## **Proposal for a new supplement to Regulation No. 110**

### **“CNG and LNG vehicles”**

#### **Submitted by the experts from the European Association of Automotive Suppliers – CLEPA**

### Example 2

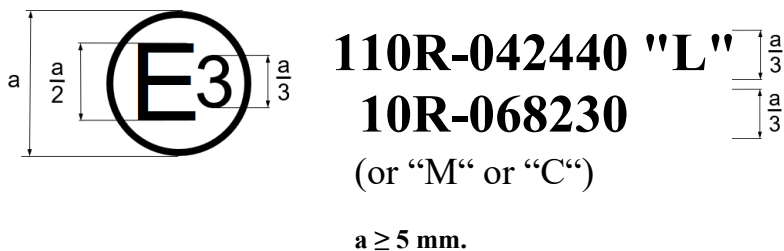
*Add a new Example 2 of the arrangement of the approval mark in Annex 2A, as follows:*

“(See paragraph 7.4.3 of this Regulation)

The above approval mark affixed to the CNG and or LNG component shows that this component has been approved in Italy (E 3), pursuant to Regulation No. 110 under approval number 042440 and pursuant to Regulation No. 10<sup>1</sup> under approval number 068230. The first two digits of the approval number indicate that the approval was granted in accordance with the requirements of Regulation No. 110 as amended by the 04 series of amendments and in accordance with the requirements of Regulation No. 10 as amended by the 06 series of amendments.
